REMARKS

Amendment Under 1.111
10/642,653

FIG. 7
PRIOR ART

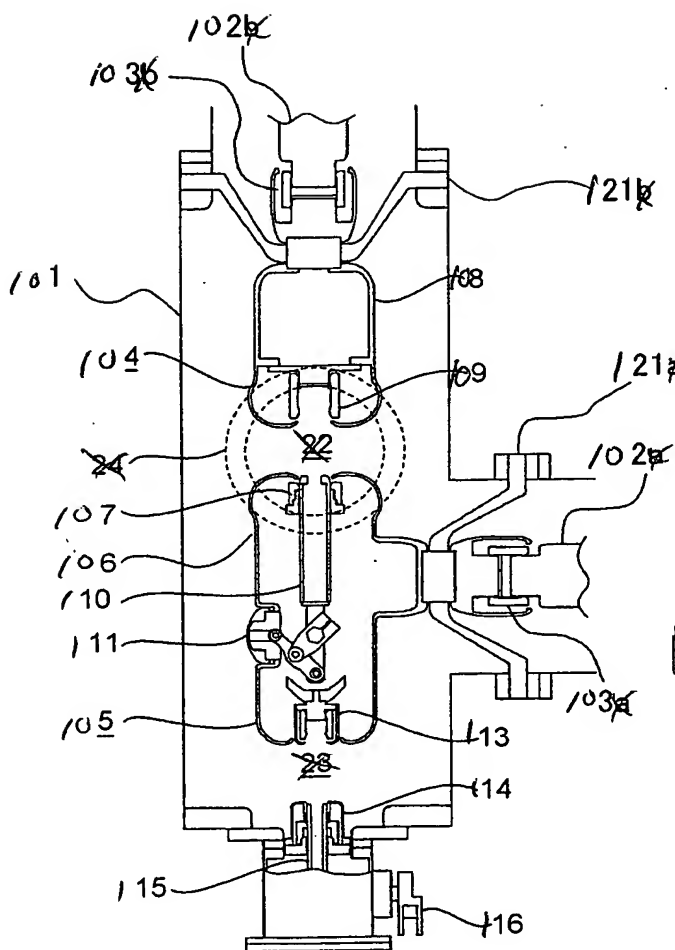
The drawings are also objected to as failing to comply with 37 C.F.R. § 1.84(p)(4) because the reference character “12” has been used to designate both an “insulation support” at page 1, line 28 and a “contact” as page 6, line 11. Similarly, the reference character 11 has been used to designated both a “first operating mechanism” at page 1, line 24 and a “contact” at page 5, line 24. The Examiner notes that there are additional reference numerals with similar dual uses in the drawings.

Upon Applicants’ review of the figures, it appears that the same numerals were used in the description of the prior art (Figs. 7 and 8) to describe structures that are different from those that apply to the invention (Figs. 1-6). This practice is confusing and, accordingly, Applicants have made an amendment to Figs. 7 and 8, using different reference numerals. In particular, Applicants now have adopted a technique of using a “100” series of numerals for the figures that illustrate the prior art. Thus, the tank in Fig. 7 (currently 1) has been given the numeral 101. Similarly the operating mechanism (currently 16) has been given a numeral 116. The first and second electrodes have been designated as 102 and 103. Applicants’ proposed amendment is submitted herewith. Appropriate amendments to the specification also have been made. No new matter has been added.

Finally, Applicants also note that the prior art figures 7 and 8 include numerals related to structures that are not defined or otherwise mentioned in the portion of the specification dealing with the prior art. In particular, elements 21a, 21b, 22, 23 and 24 are not mentioned in the text at pages 1 or 2. Thus, these pages have been rewritten (1) consistent with a change in the reference numerals for Figs. 7 and 8 and (2) in order to add a description of the structures related to structures 21a and 21b, and to remove reference numerals 22, 23 and 24 from the Figures as they are not necessary to understand the invention. Again, no new matter has been added.
